**ADDRESS: 2021 CHICAGO**

**APPLICATION NO: #23-8334**

**HISTORIC DISTRICT: BOSTON EDISON**

**SCOPE: INSTALL VINYL WINDOWS (WORK COMPLETED)**

**Current conditions at front elevation, primary entrance, photo taken by HDC staff on 4/23/2023**

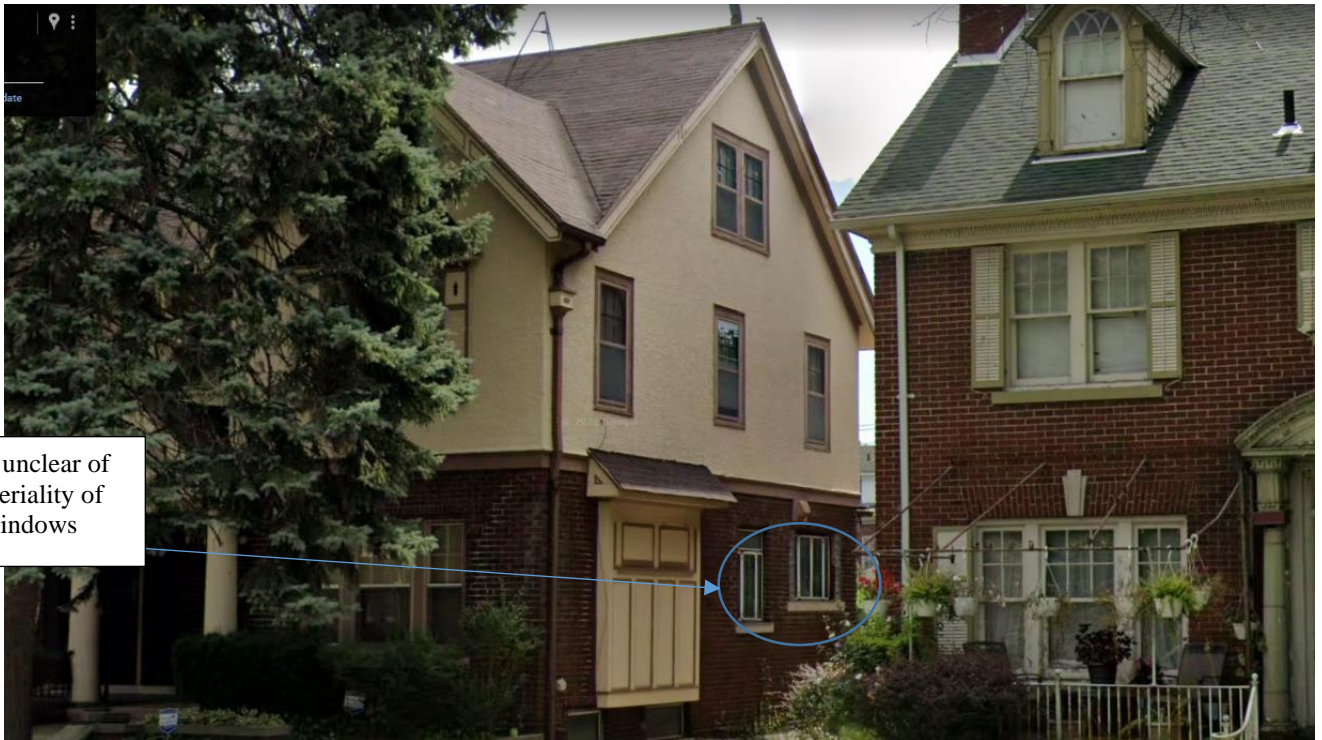
- Per the above description and attached photos, please note that the current applicant has removed the building's original window sash and installed new vinyl units without HDC approval and/or permit. However, note that the original wood brickmould/trim remains intact.
- HDC staff was made aware of the violation in progress on 3/13/2023. Staff therefore reported the unapproved windows replacement to the building department that same day. The building department subsequently issued a Stop Work order on the property in response to the reported window violation (see below photo)
